IN THE DRAWINGS:

**(REPLACEMENT SHEETS OF FIGS. 1 and 4
AND ANNOTATED SHEETS SHOWING CHANGES)**

(Serial No. 10/627,199)

FIG. 1 (Prior Art)

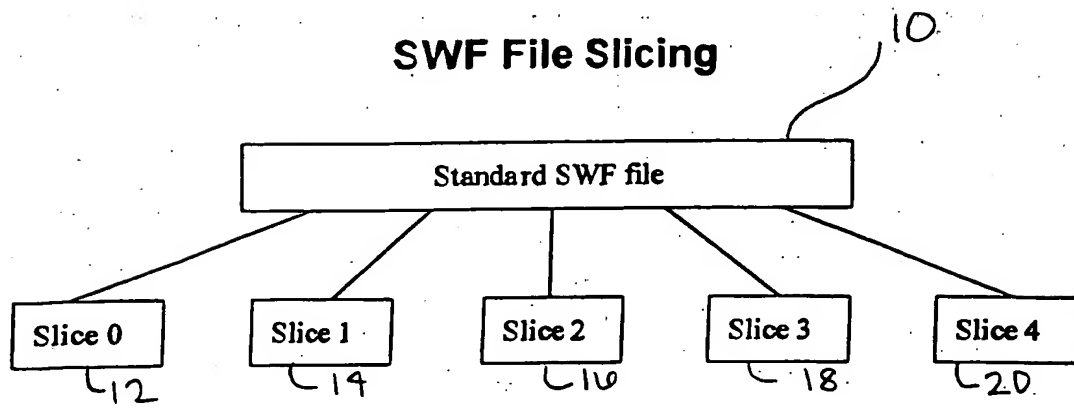
FIGS. 1 and 4 have been amended herein. Specifically, FIG. 1 has been revised to add the reference numeral --10-- with appropriate lead line; and FIG. 4 has been revised to change the wording within the box of reference numeral "50" to read --AUTOMATED COMPRESSION ENGINE--. No new matter has been added.
